Reduction in V_f (max) and Associated Parameters (Comments 345-360)

Reduction in Vf Max and Associated Parameters

Proposed Changes to Draft

COM Simulations for CR

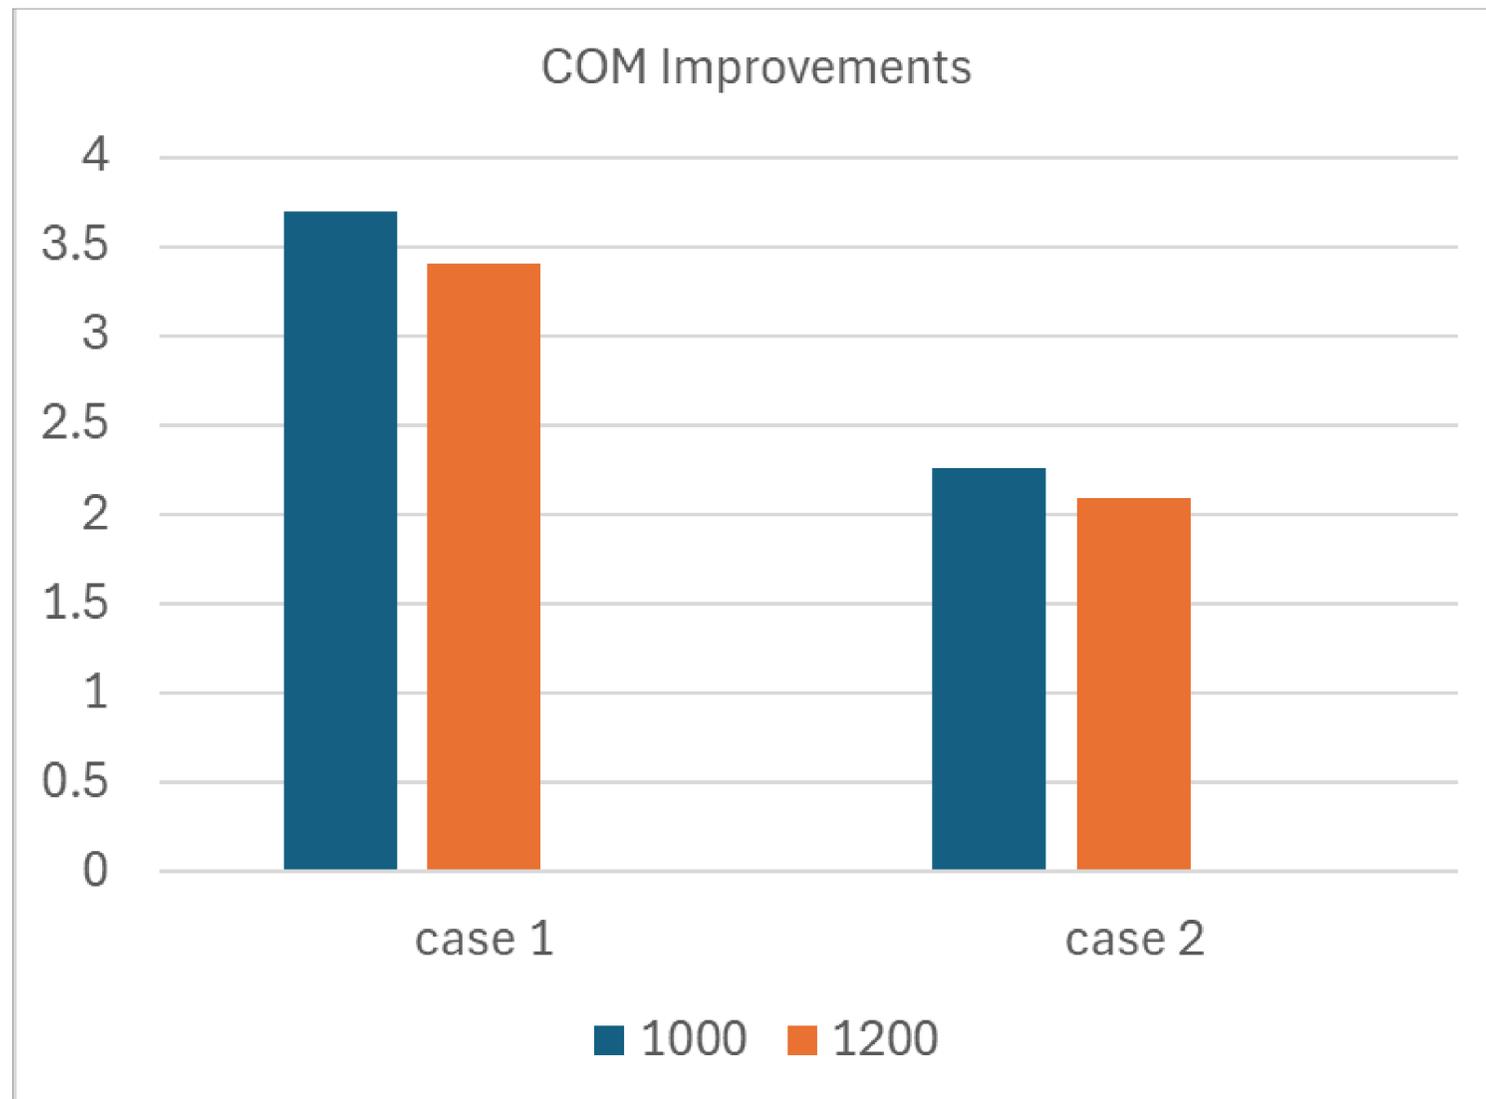
0.3dB and 0.17 dB COM improvements

- Example Case showing improvement of reducing the xtalk terms
- Simulations of marginal passing and marginal failing CR channels (Case 1 vs Case 2)
- Channels run with A_{ne} .6V and then 0.5V mV
- Improvements noted in COM by reducing A_{ne} relative to other parameters
- Further investigation may show additional improvements of other COM parameters
- This example:
 - uses akinwale_3dj_01_2311, 22dB channel vendor X
 - COM4.6
